Re: In the Matter of the Proposed Listing
of Richardson Flat Tailings, Summit
County, Utah, on the National Priorities
List (Update 7)

IN THE MATTER OF THE PROPOSED)	COMMENTS OF UNITED PARK
LISTING OF RICHARDSON FLAT)	CITY MINES COMPANY IN
TAILINGS, SUMMIT COUNTY, UTAH,)	OPPOSITION TO PROPOSED
ON THE NATIONAL PRIORITIES LIST)	RULE

MAP 2

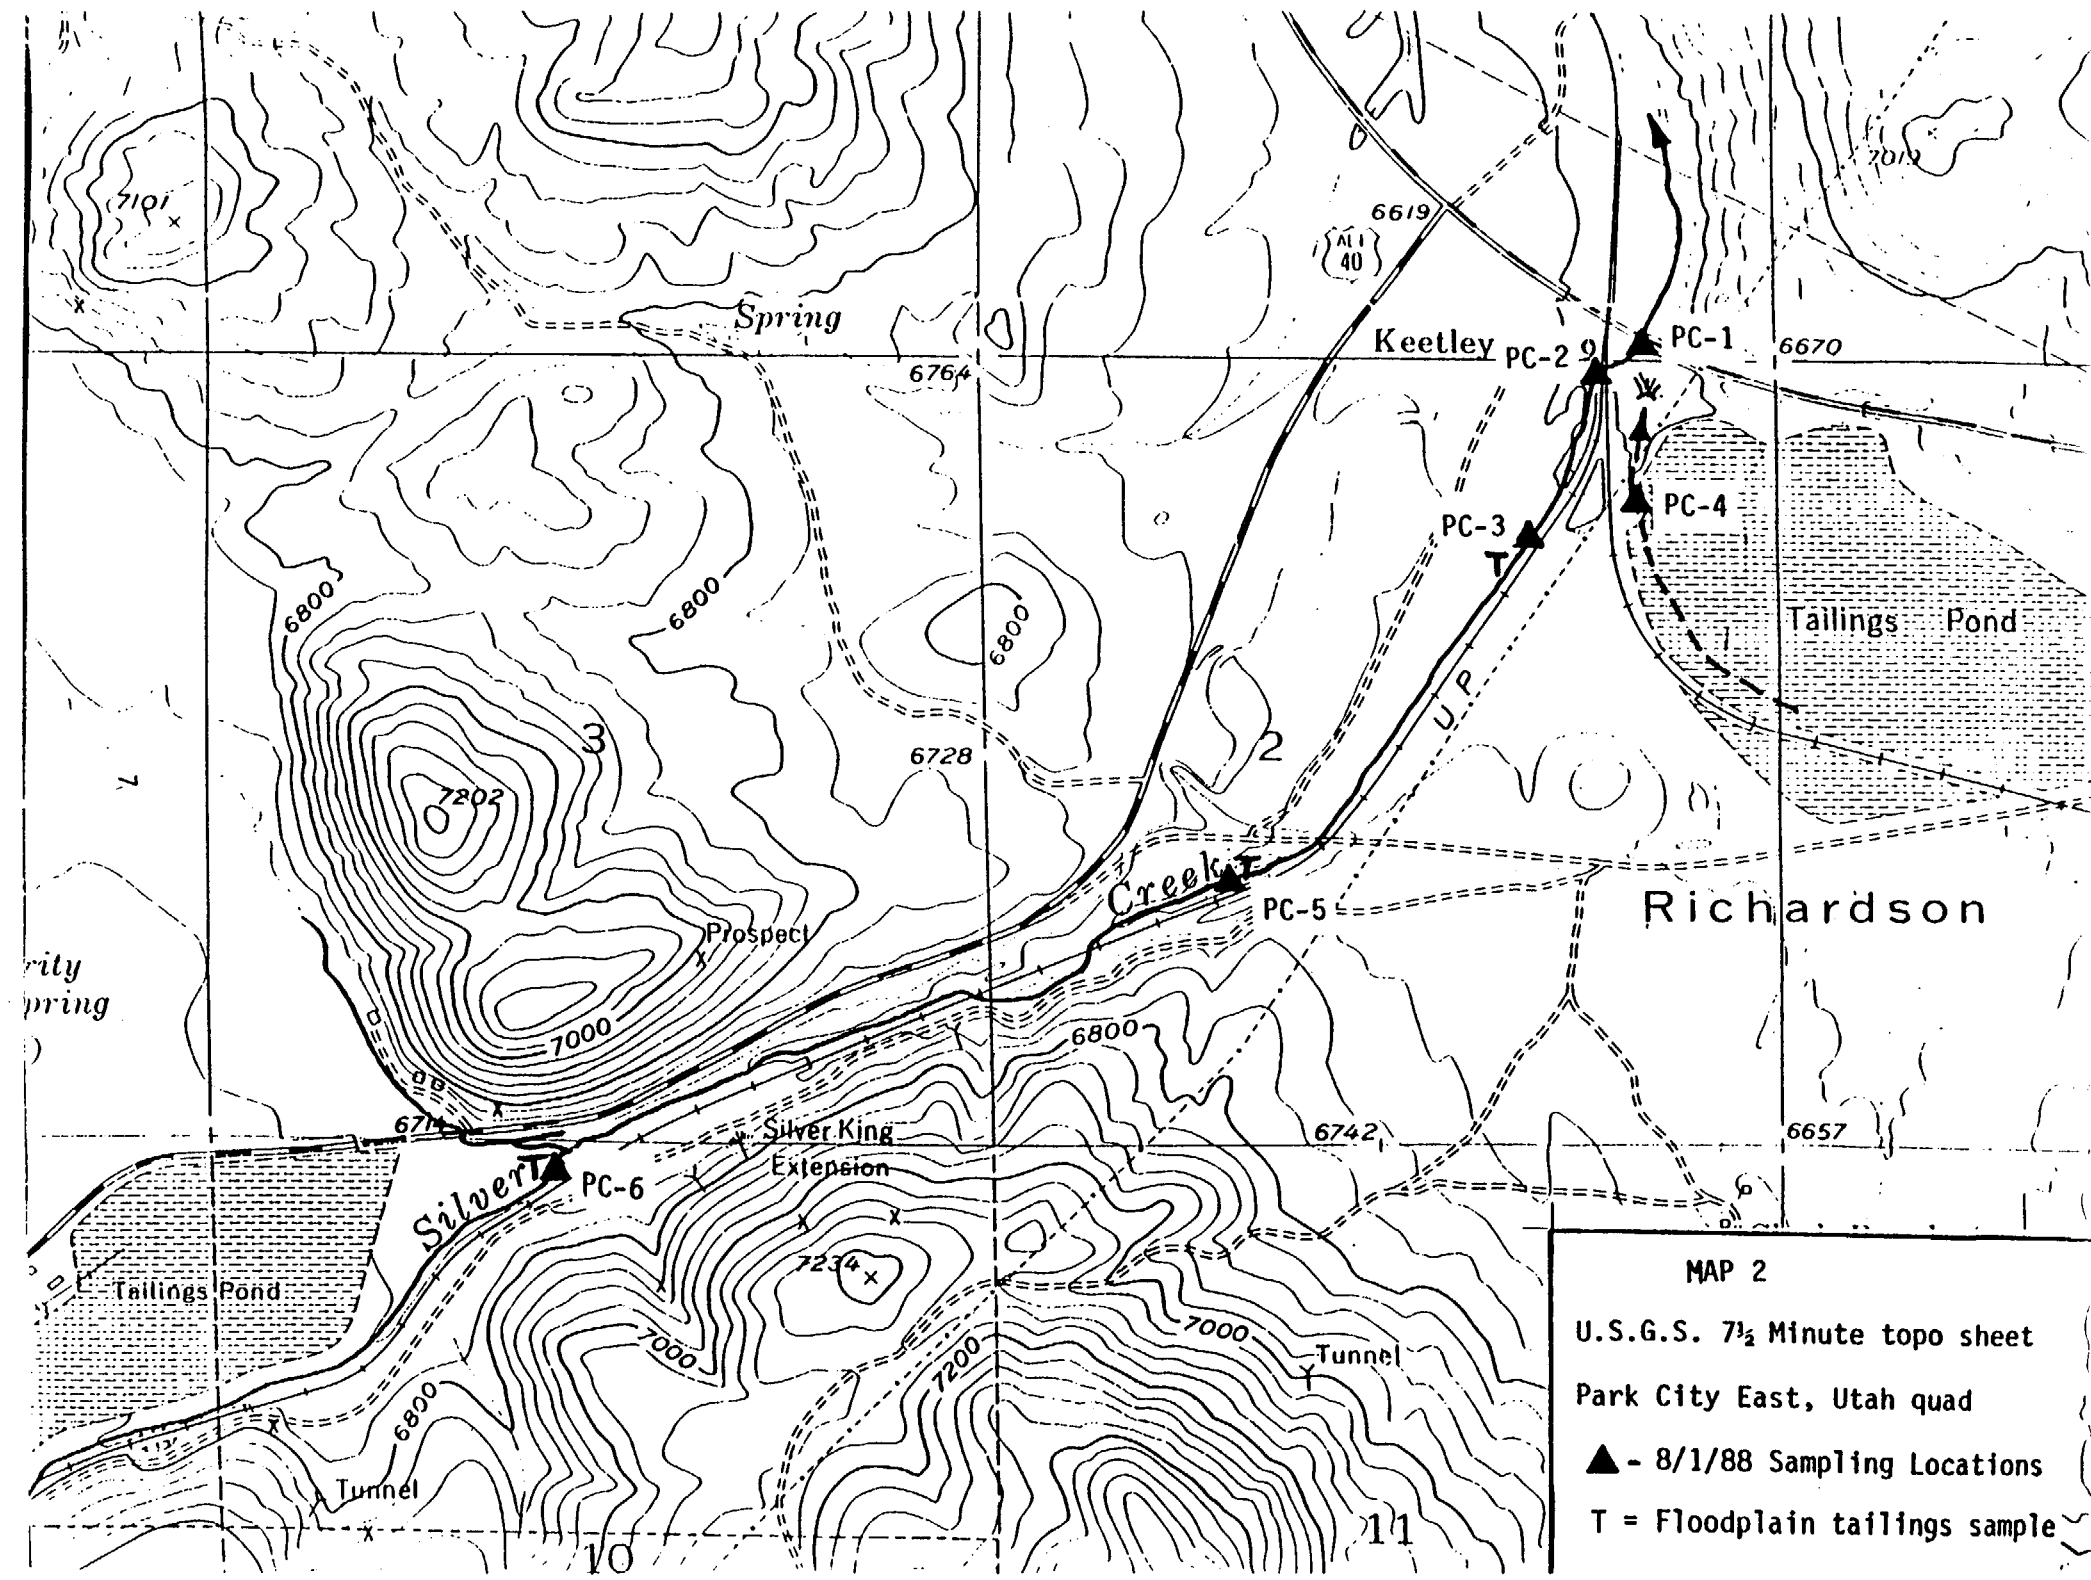
Consequently, the suspended load within Silver Creek can contain these tailings and associated metals. Total metals analyses reflect these suspended tailings in the stream water and show a great deal of variance depending on sampling methodology, sampling locations, and seasonal variables (spring runoff, storms, dry periods, irrigation withdrawals, etc.). These factors can easily account for the high metal concentrations found in RT-SW-3 by E&E in 1985. Filtered water samples are specific to dissolved metals and eliminate the influence of suspended particulate material. These samples provide a more accurate measure of metal content in the water available for uptake by plants, humans, and livestock. Table 2 compares total and dissolved metal concentrations found in Silver Creek on August 1, 1988 (locations correspond to those on Map 2).
